Report Type: DA Access Report
Reference Number: 19010
Client: Hills AWRAF Pty Ltd c/o IConfirm Australia Pty Ltd
Site Address: Corner of Glenhaven Road and 1 Larapinta Place,
Glenhaven NSW

ACCESS REPORT

This Access Compliance Report is to accompany a Development Application for the development proposed at Corner of 1 Larapinta Pace and Glenhaven Road, Glenhaven NSW.

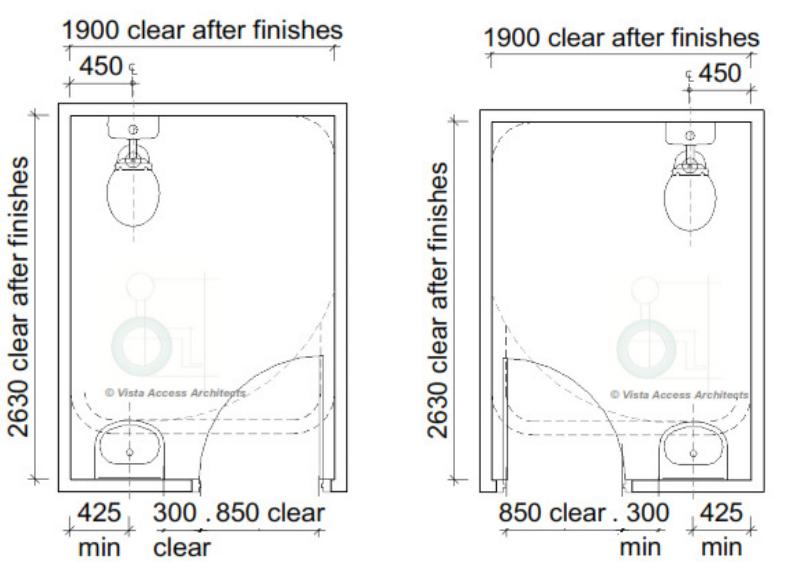
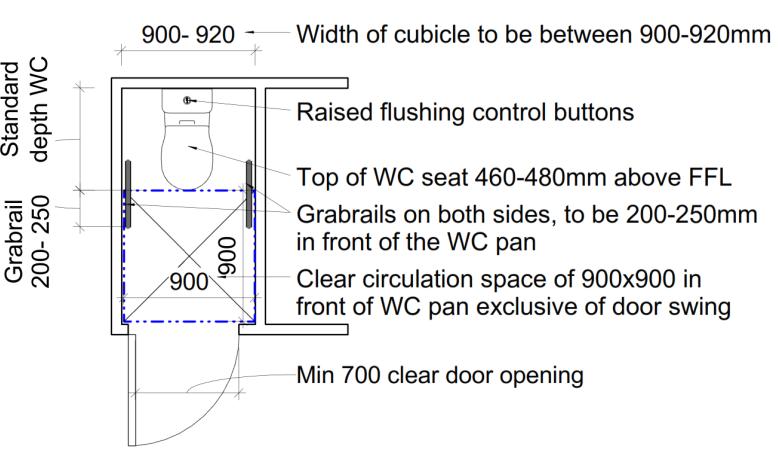
AS2890.6-2009 requirements for Accessible car parking space	
Requirement	<ul style="list-style-type: none"> - Dedicated space 2.4Mx5.4M, Shared space 2.4Mx5.4M at the same level - Slip resistant flooring surface with maximum fall 1:40 in any direction or maximum 1:33 if bituminous and outdoors. - Central Bollard in shared space at 800+/-50mm from entry point . - Pavement marking in dedicated space by means of access symbol between 800mm-1000mm high placed on a blue rectangle of maximum 1200mm and between 500mm-600mm from its entry point (marking not required where allocated to an Adaptable unit). - Minimum headroom of 2.2M at entrances and 2.5M is required over shared zones as well as dedicated spaces. - Non-trafficked area of the shared space to have marking strips at 45°, 150-200mm wide at 200mm-300mm spaces (not required where driveways are used as shared spaces)
Compliance Comments	<p>Capable of compliance.</p> <p>Details to be verified at the CC stage of works.</p> <p>Refer to diagrams below for requirements, especially in regards to head height requirements.</p> <p>Note: The pavement marking shall have the appropriate slip resistance for the location. This requirement is to be added to the project specifications to ensure compliance.</p>  <p>Front of car parking space © Vista Access Architects</p>

The Accessible parking, shared zones, linemarking and bollards to be as shown above.
